**COMMERCIAL REDEVELOPMENT**  
3615 NM HWY 528  
Albuquerque, NM

**SHEET TITLE:**  
DRB -FINAL SIGN-OFF  
FOR EPC APPROVED SDP  
FOR SUBDIVISION

DESCRIPTION OF REQUEST: DRB final sign-off / approval for site plan for subdivision as approved by EPC project # 1010999

**Project# 1010999**  
16EPC-40050 Site Development Plan for Subdivision

**A-1 SITE PLAN**

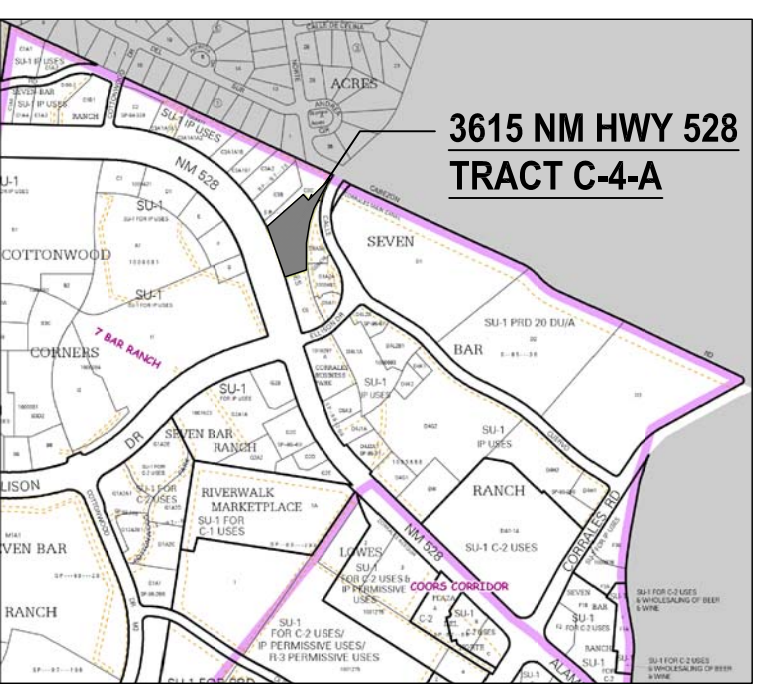
3. *All future Site Development Plans for Building Permit will be subject to approval by the EPC.* RESPONSE: Noted
4. *The zoning designation listed in the Site Data Section on Sheet A-1 currently reads "Su-1/IP, and shall be amended to read "SU-1 for IP Uses".* RESPONSE: Revision made to Site Date Section of Sheet A-1

6. City Engineer Conditions of Approval:
  - a. *Developer is responsible for permanent improvements to the transportation facilities adjacent to the proposed development site plan, as required by the Development Review Board (DRB)* RESPONSE: See 'Site Plan General Notes # 1 Sheet A-1

7. Public Service Company of New Mexico Condition of Approval:
  1. *It is the applicant's obligation to determine if existing utility easements or rights-of-way are located on or adjacent to the property and to abide by any condition or terms of those easements.* RESPONSE: See 'Site Plan General Notes' #10 Sheet A-1

RESPONSE: See 'Site Plan General Notes' #9 Sheet A-1
  3. *Ground-mounted equipment screening will be designed to allow for access to utility facilities. All screening and vegetation surrounding ground-mounted transformers and utility pads are to allow 10 feet of clearance in front of the equipment door and 5-6 feet of clearance on the remaining three sides for safe operation, maintenance and repair purposes. Refer to the PNM Electric Service Guide at [www.pnm.com](http://www.pnm.com) for specifications* RESPONSE: Note added to 'Site Plan General Notes' #4 Sheet A-1

RESPONSE: See 'Site Plan General Notes' #2 Sheet A-1
9. *The subdivision of the site shall comply with the purpose, intent, and regulations of the Subdivision Ordinance (14-14-1-3)"* RESPONSE: See 'Site Plan General Notes' #6 Sheet A-1

10. *The Site Development Plan shall comply with the General Regulations of the Zoning Code, the Subdivision Ordinance, and all other applicable design regulation, except as specifically approved by the EPC* RESPONSE: See 'Site Plan General Notes' #7 Sheet A-1

11. *A cross-access and parking agreement shall be recorded prior to the recording of the plat.* RESPONSE: See 'Site Plan General Notes' #8 Sheet A-1

ARCHITECT:
Architect:
Clint Wilsey
clint.wilsey@gmail.com
505 280-0043
DRAWN BY: CJW
ISSUE: -
COMMERCIAL REDEVELOPMENT
3615 NM HWY 528
Albuquerque, NM
DATE: 12/5/16
SHEET TITLE:
DRB -FINAL SIGN-OFF
FOR EPC APPROVED SDP
FOR SUBDIVISION
A-2 DESIGN STANDARDS

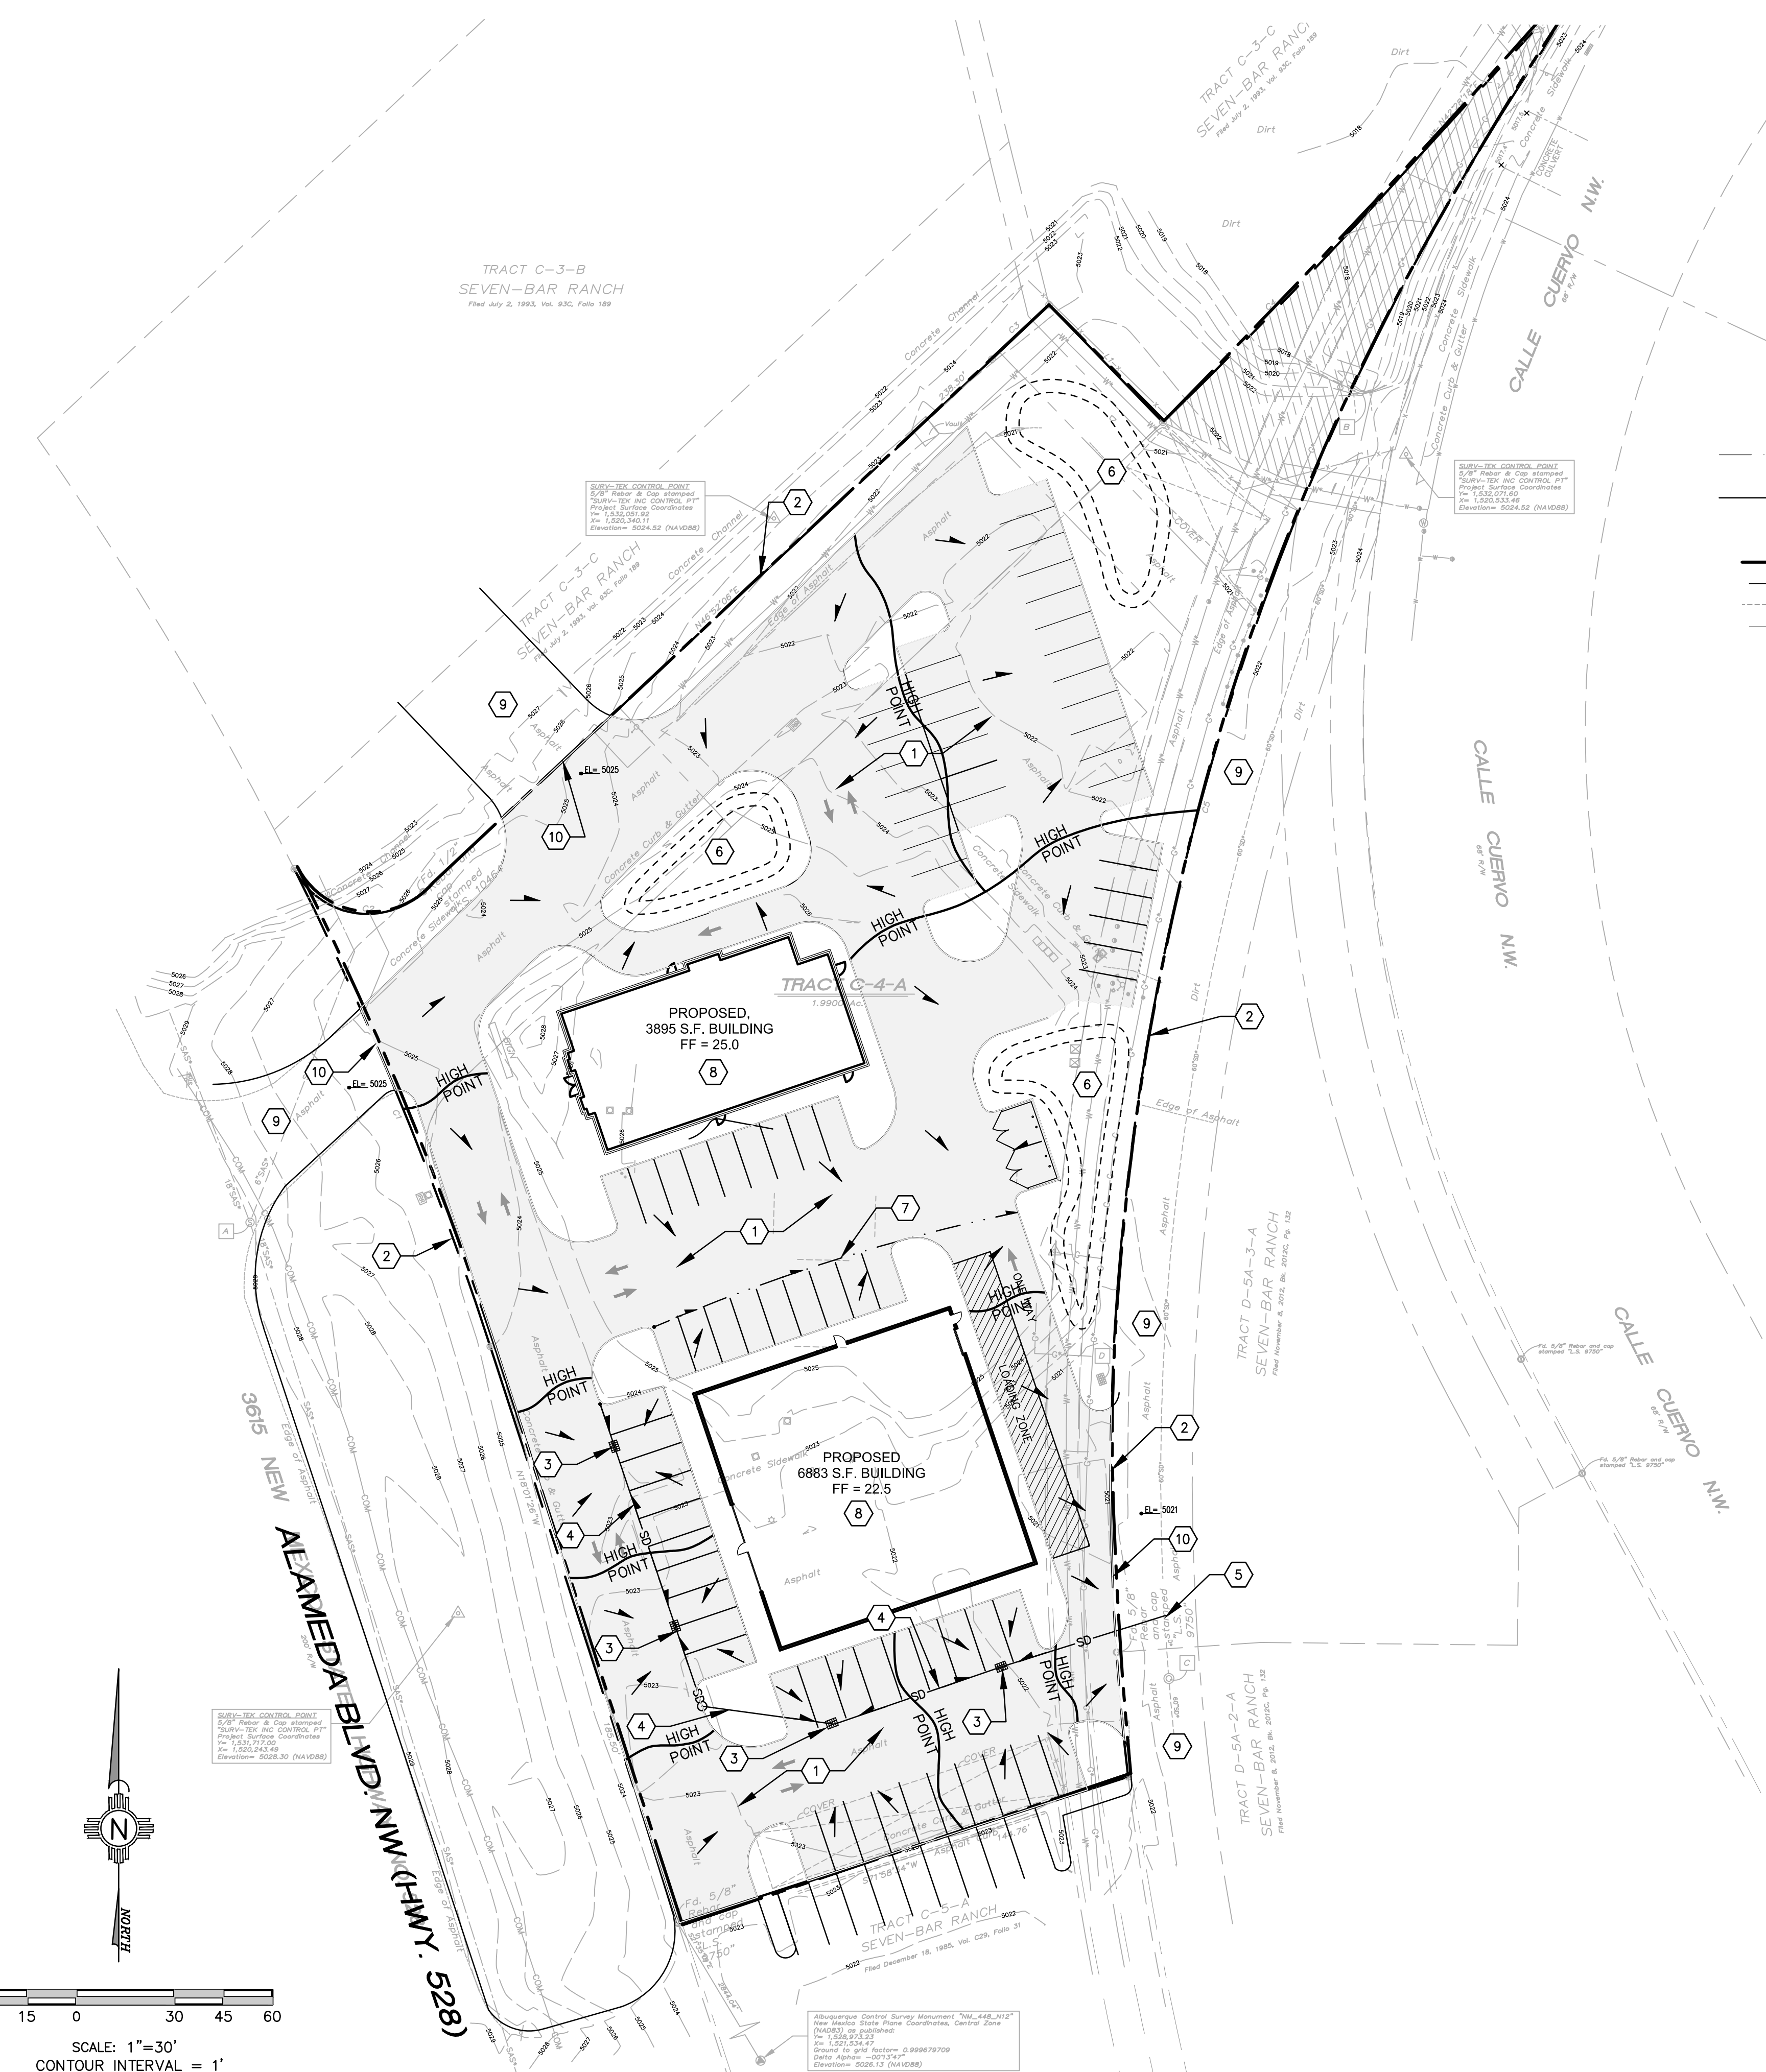
5. *The Design Guidelines on Sheet A-2 shall be amended according to the following:*
  - a. *All citations / referenced sections of the Zoning Code contained within the Design Standars must include the title / descriptor of that Zoning Code Section.*

RESPONSE: Documents reviewed to assure all citations reference Zoning Code sections.
  - b. *Section V.h. (Walls, Fences & Screening) currently reads "The used of razor ribbon, razor wire, barbed wire, chain link fencing..", and shall be amended to read "The use of razor ribbon, razor wire, barbed wire, chain link fencing.."*

RESPONSE: Correction made to Section V h. See sheet A-2
  - c. *Section IX a. (Signage) currently reads "Signage shall comply with Section 12-16-3-5.." and shall be amended to read "All signage on the subject site must comply with Sections 14-16-3-5 (General Sign Regulations) and 14-16-2-19(A)(25)(Industrial Park Zone). Per these requirements, one free-standing sign is permitted for each street frontage, or joint sign premises, which has at least 200 feet of street frontage. This would allow a single 26' high, 100 sq. ft. sign on th e subject site along NM Hwy 528. A maximum of twenty percent of the building facades facing NM Hwy 528 may be used as building mounted signage area".* RESPONSE: Section IX a. amended and revised. See Sheet A-2
